SEWAGE DISPOSAL SYSTEM

DEPARTMENT OF HEALTH AND MENTAL HYGIENE

SUBDIVISION Highland Lakes LOT 16 ROAD 6636 Isle of Skye Drive

REPAIR - PURPOSE - SEPTIC SYSTEM HAS FAILED
Call for inspection when ground is opened so sanitaian can recommend repa

OSKAR SCHULTZ, INC. 115 ROOSEVELT DR. SYKEVILLE, MD.		
SCALE 1" = 50'-0"	APPROVED BY:	DRAWN BY: WM. YOUNG
DATE: NOVEMBER 5, 1978		JOB NUMBER: 78-020
SITE PLAN		
RESIDENCE FOR 6636 ISLE OF SKYE DRIVE, HIGHLAND, MD.		DRAWING NUMBER: SP-1

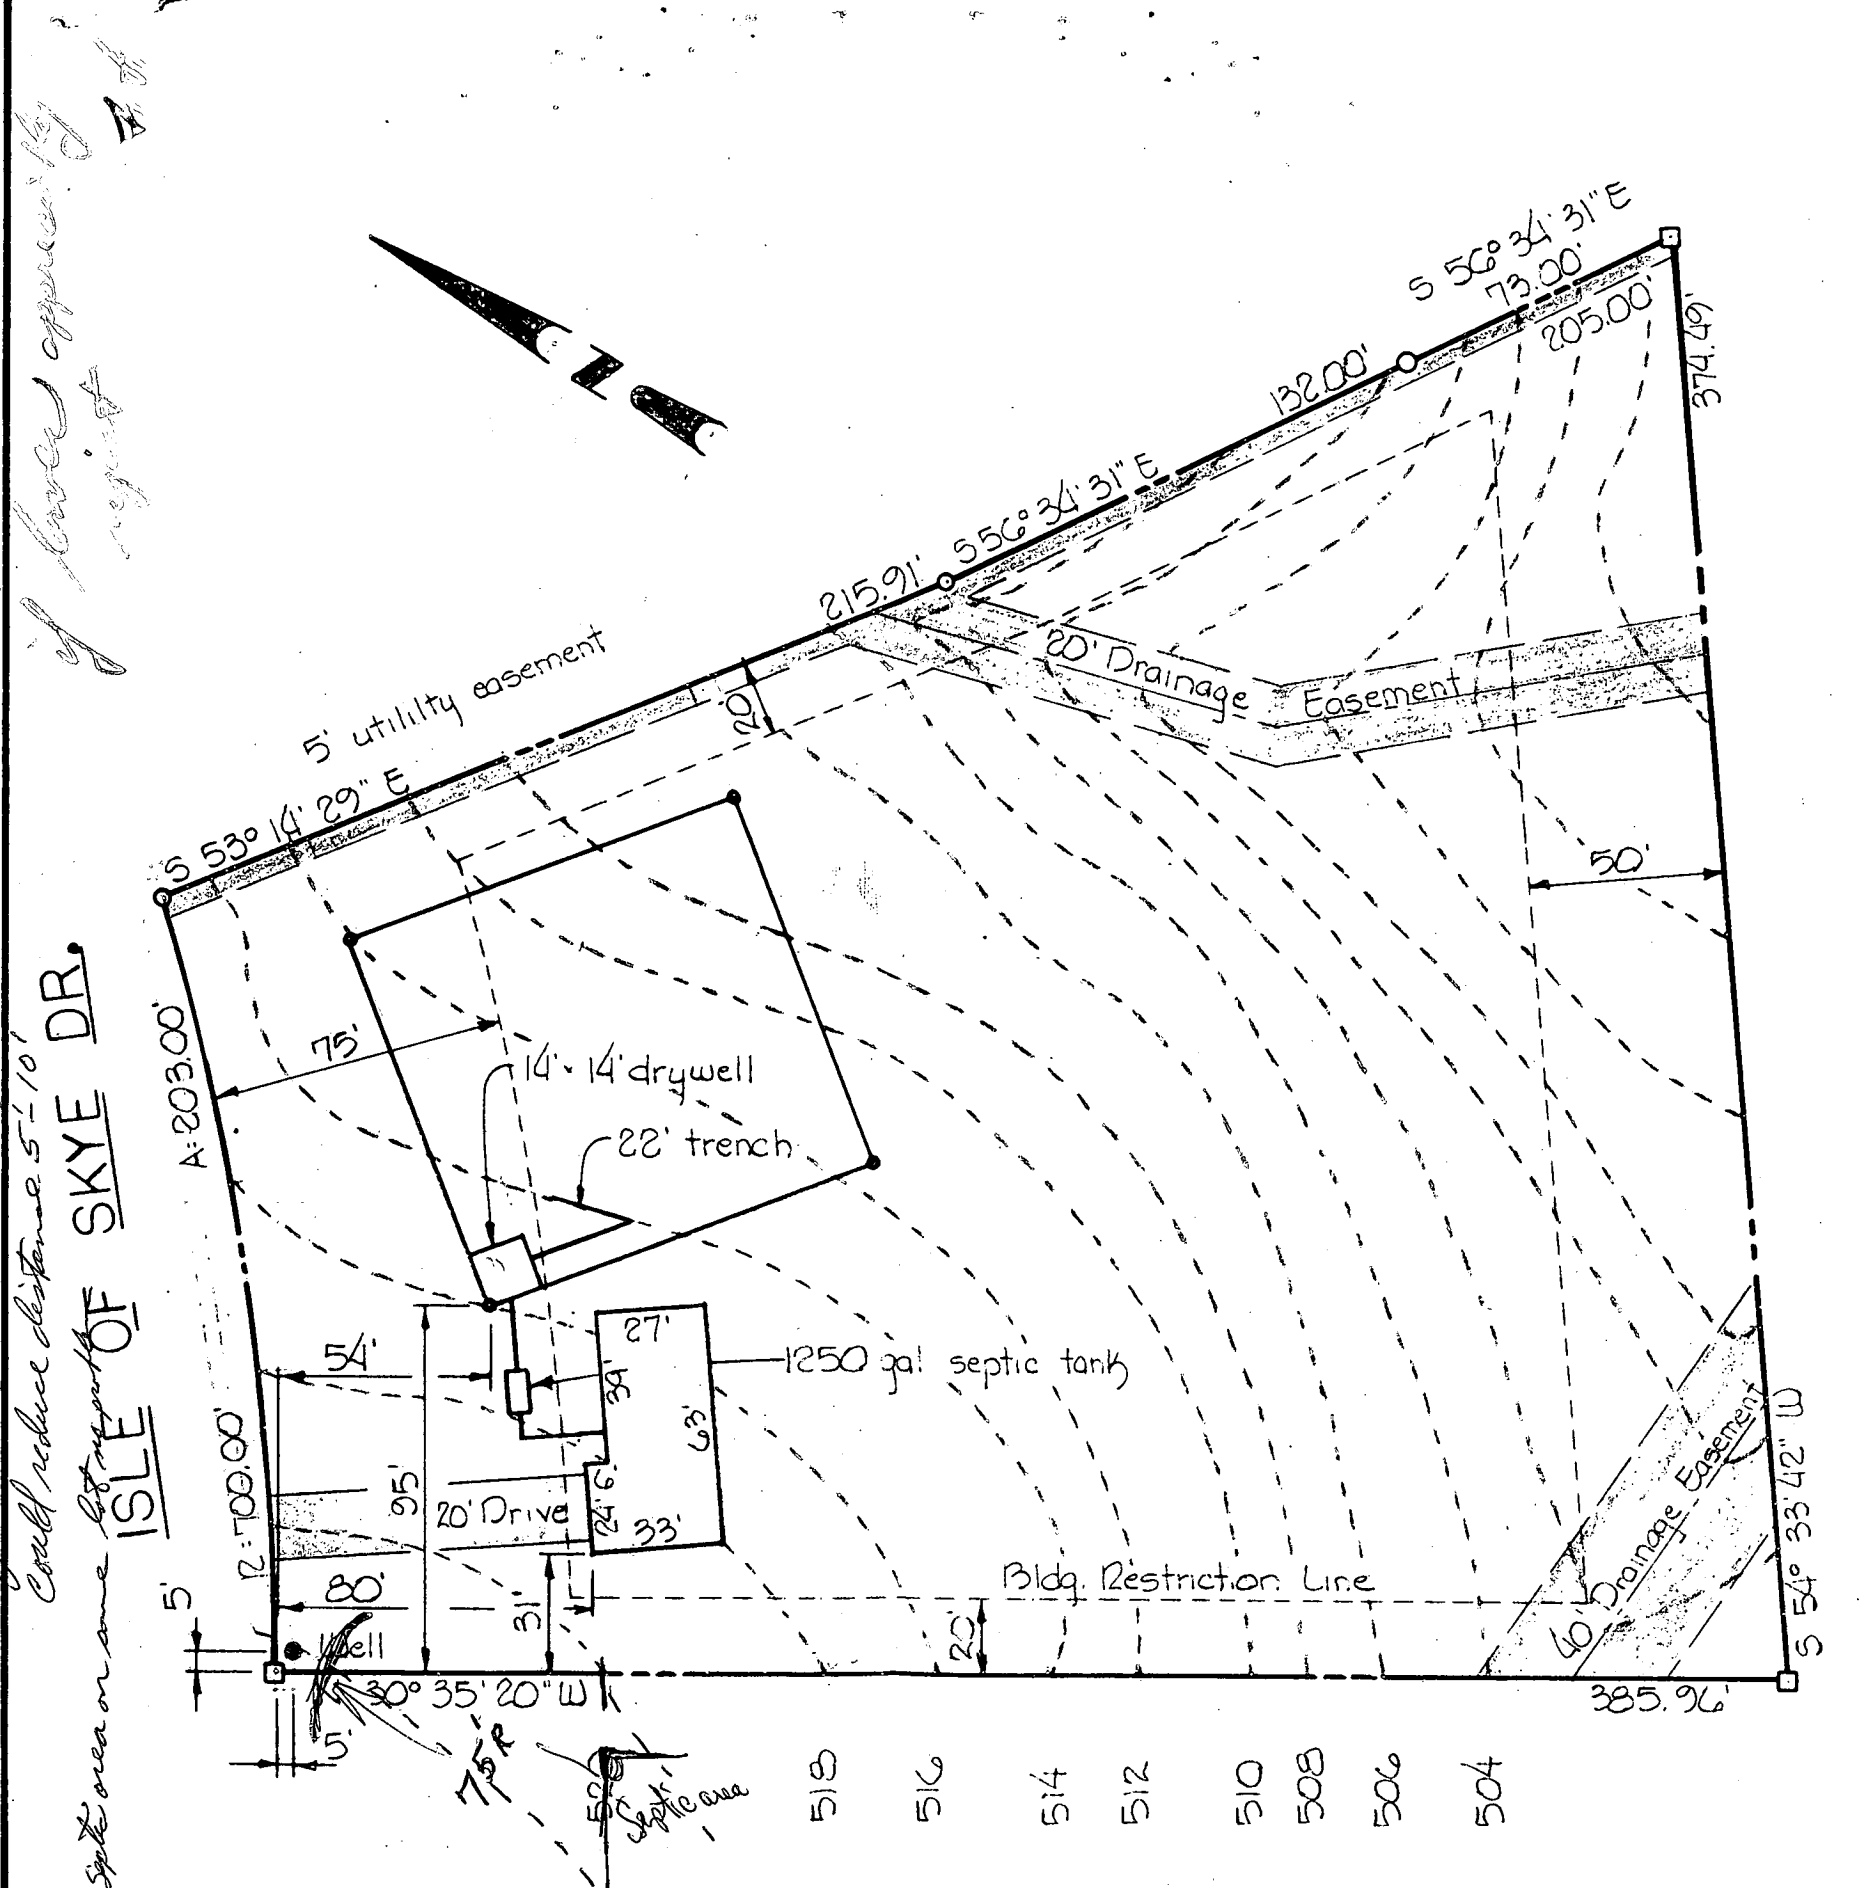
* as long as well sets higher - check top of

could reduce distance 5'-10'
 Septic area on one lot in part of ISLE OF SKYE DR.
